**PROJECT: Multi-Sport Venue in Eastern New Orleans and Lower Ninth Ward
4290 Almonaster Avenue,
New Orleans, LA 70126**

ADDENDUM NO. 6

July 2, 2025

This Addendum forms a part of the Contract Documents and modifies the Project Manual – Volume 1 and 2, and Drawings dated January 30, 2025. Clarifications and revisions noted below are in response to the project solicitation posted on May 29, 2025.

L2.1

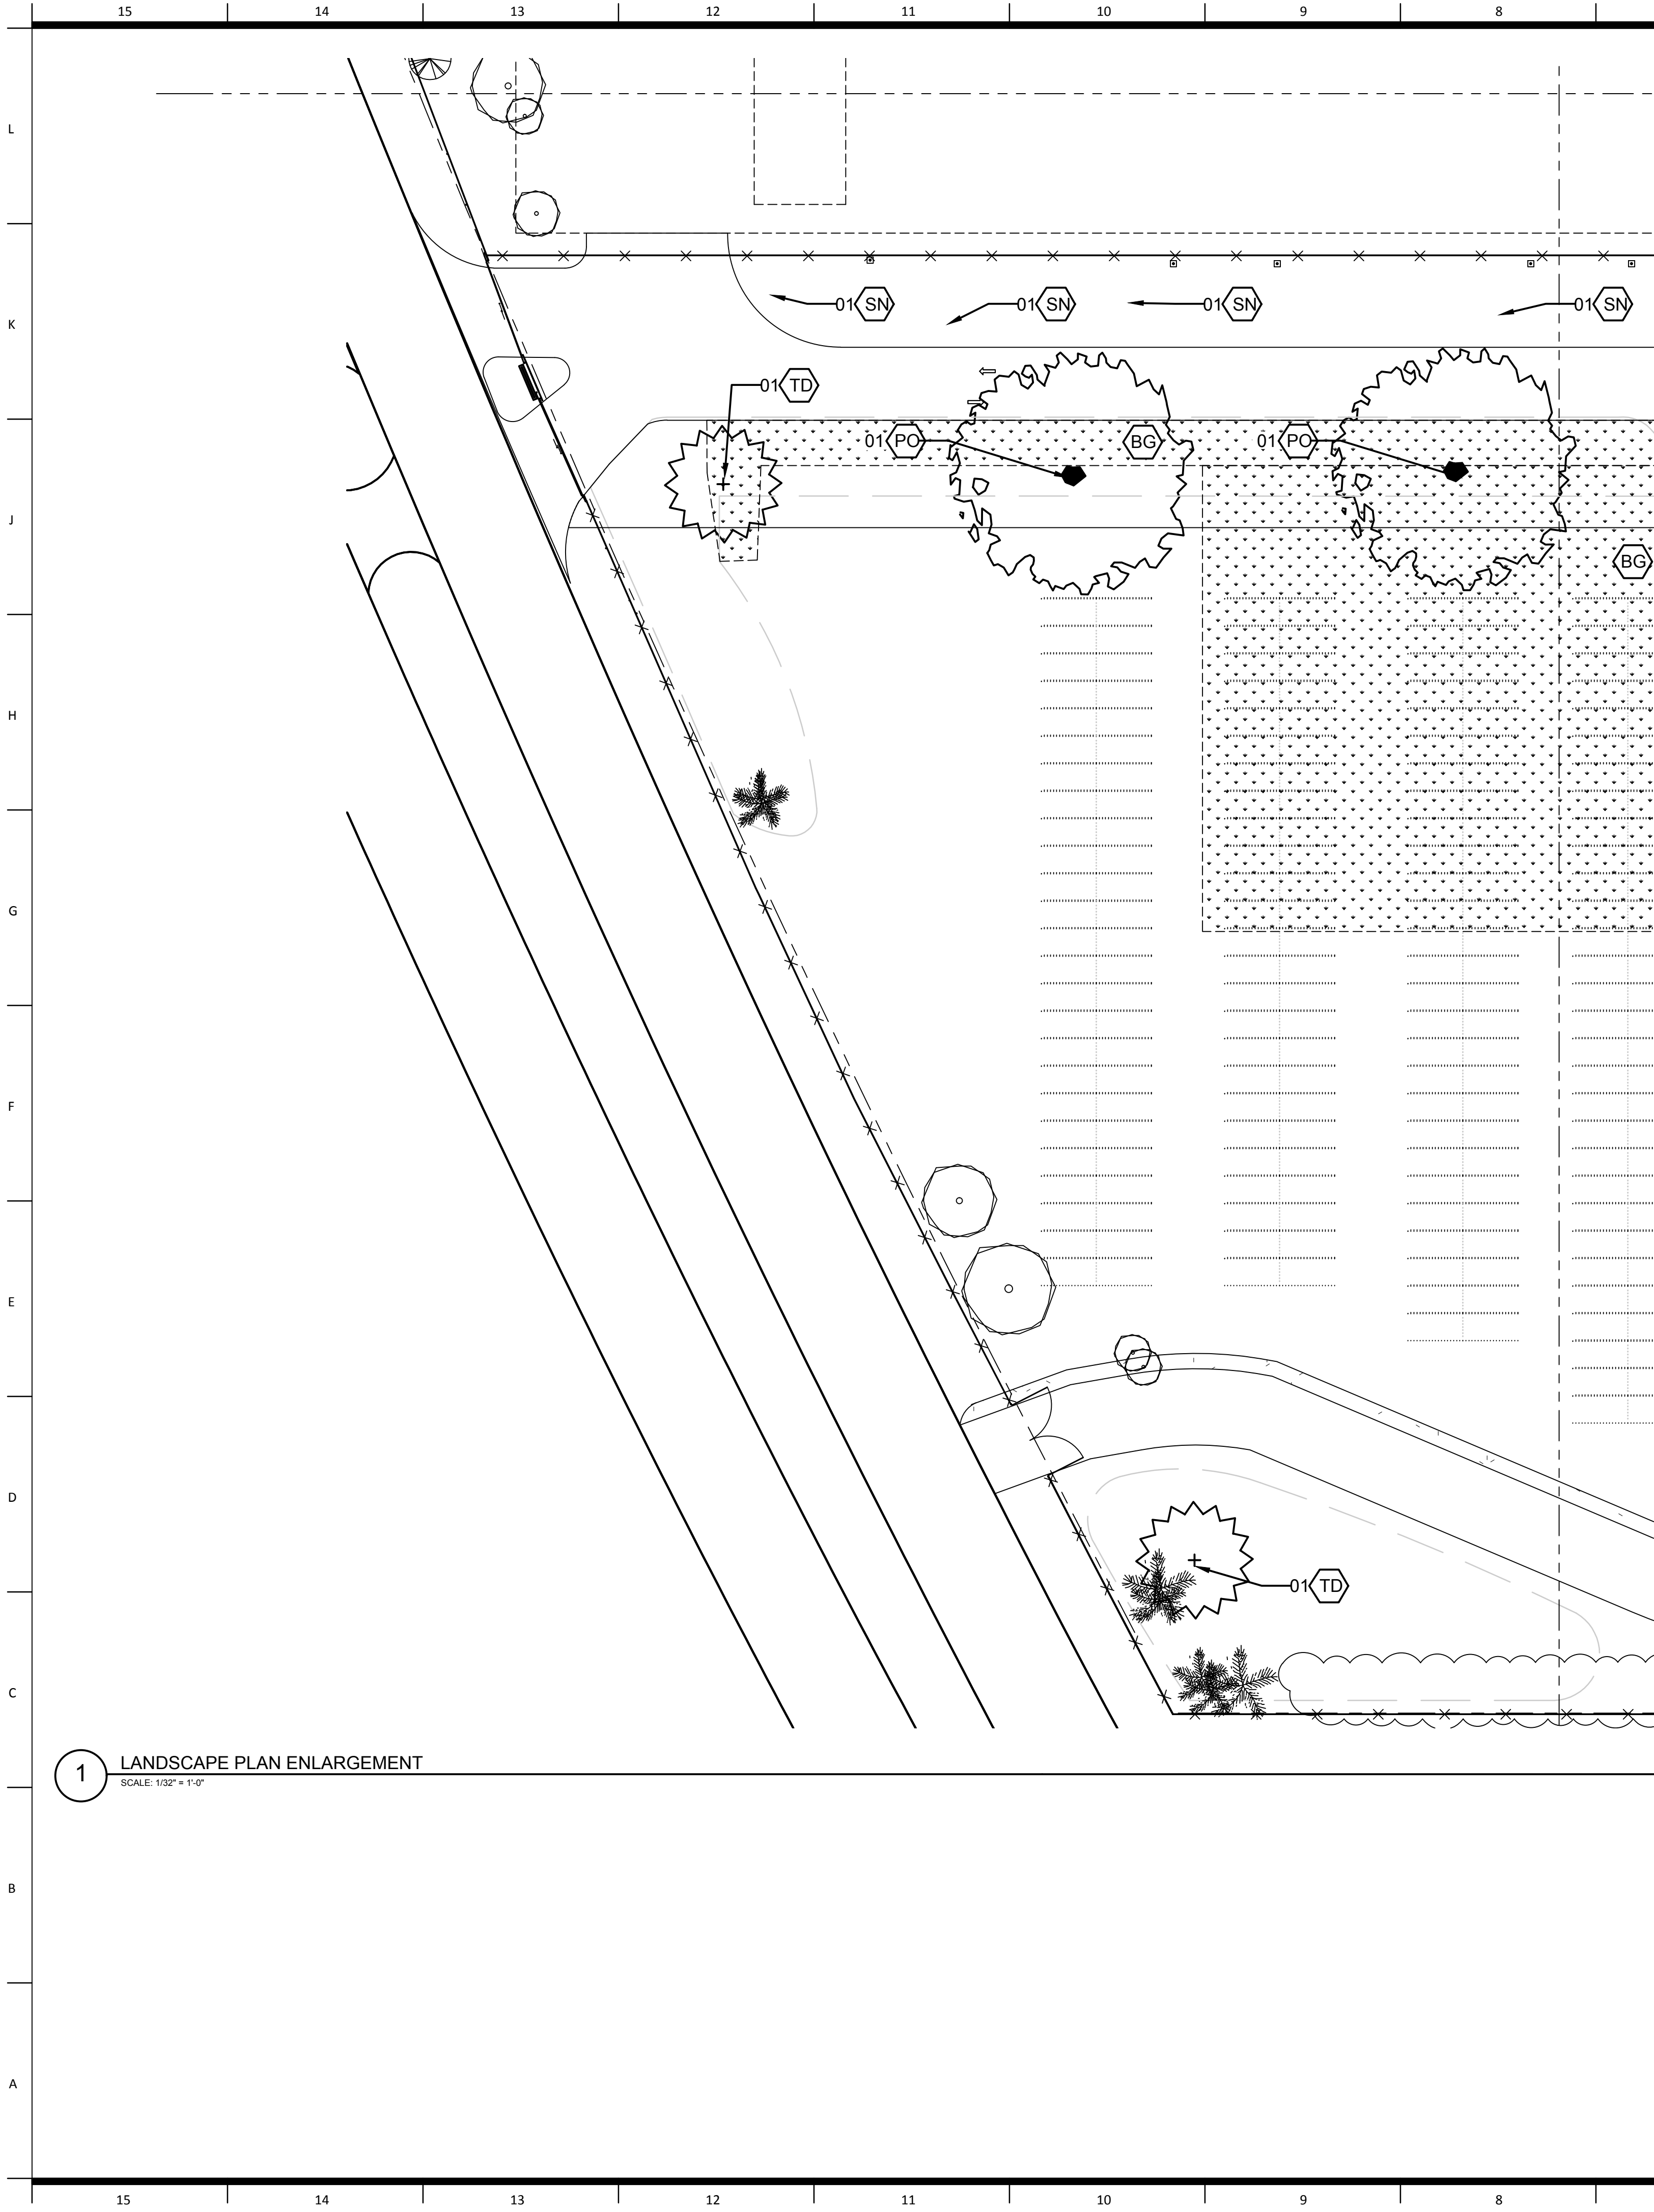
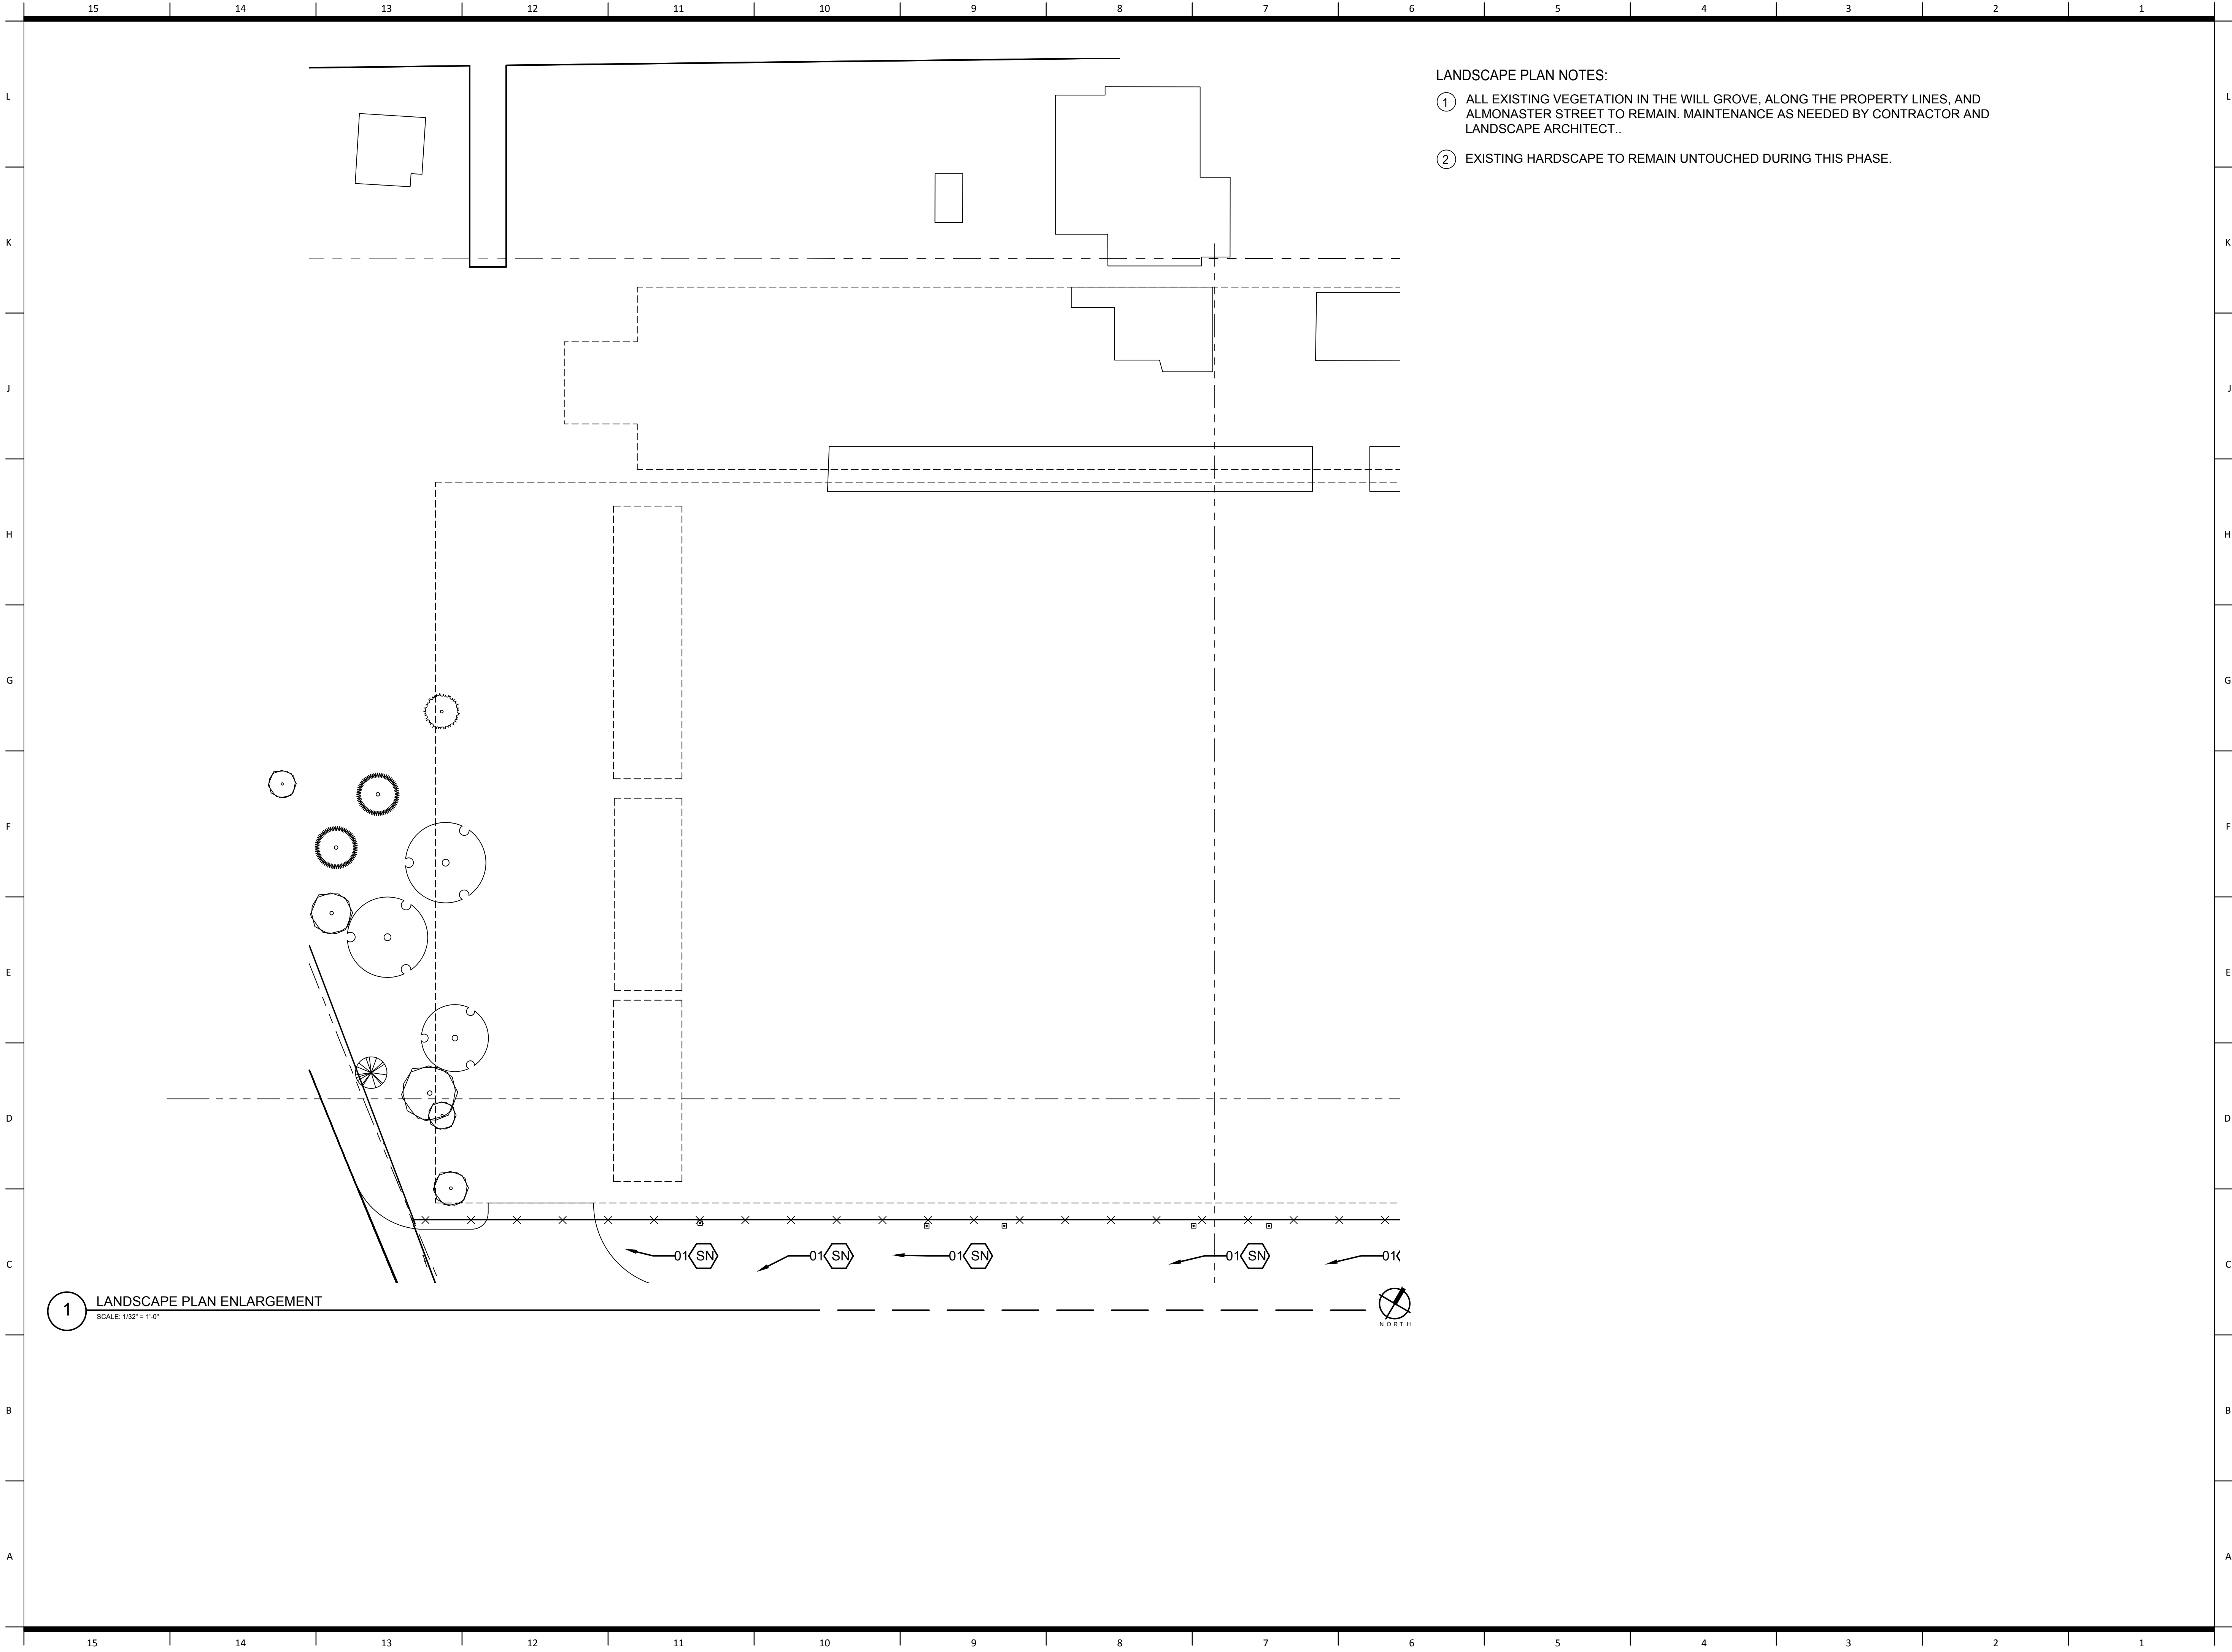
9. The landscape plan planting legend shows BG identifying Bermuda grass seed, but it is not called out anywhere on the landscape plan the way the other plant abbreviations are called out. Can you please clarify.

- See attached revised plans for extents of BG tags
10. There is a note on page A101.7P5 that mentions an add alternate, however this is not listed in the alternate section nor on the bid form. Please clarify.

NEW BERMUDA GRASS SEED AREAS ARE MARKED WITH HATCH PATTERN. "BG" SYMBOL HAS BEEN ADDED TO HATCH AREAS.
